## HUB REVIEW FINDINGS - MILLBRAE BART/CALTRAIN STATION

October 24, 2006

12. SamTrans bus shelter and boarding area. Note schedule is difficult to find.

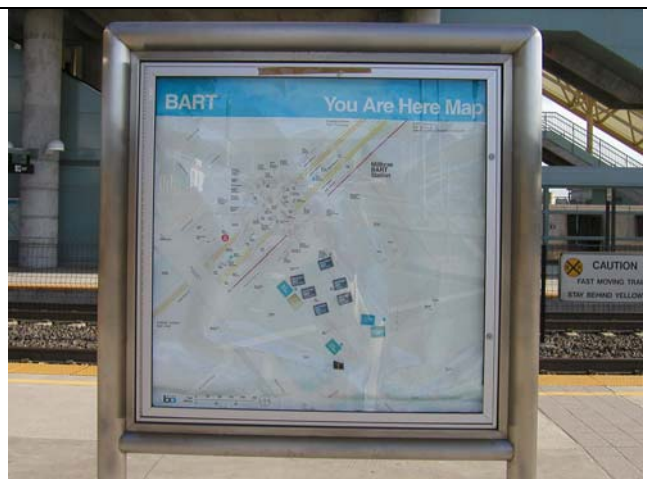
- Caltrain platforms are clearly identified but it is often difficult to determine which platform is correct for which direction (see checklist #18);
- Install consistent Braille signs on all bus stop poles and/or shelters. In addition, many bus stops do not use poles for mounting bus flags. This will make it difficult for limited-sight passengers to find their bus. Use mounting hardware that allows for changeable route information (see checklist question #23, photos #7, 16);
- Bus stop location maps need improvement. They are difficult to locate and to read (photo #13).

- Install and prominently display appropriately sized and legible bus schedules and route information at all bus stops/shelters (see checklist questions, #20, 25);
- The hub layout and hub vicinity maps currently provided at the Millbrae Station are the best examples of clear, easy to read maps. The maps include: detailed and accurate renderings of the station layout illustrating all access points (entrances, exists, elevator locations), “you are here” identifiers, nearby key points of interest, a regional context map. As such, they should be employed as models of what could be provided throughout the region (see checklist questions #29, 30, photo #19);
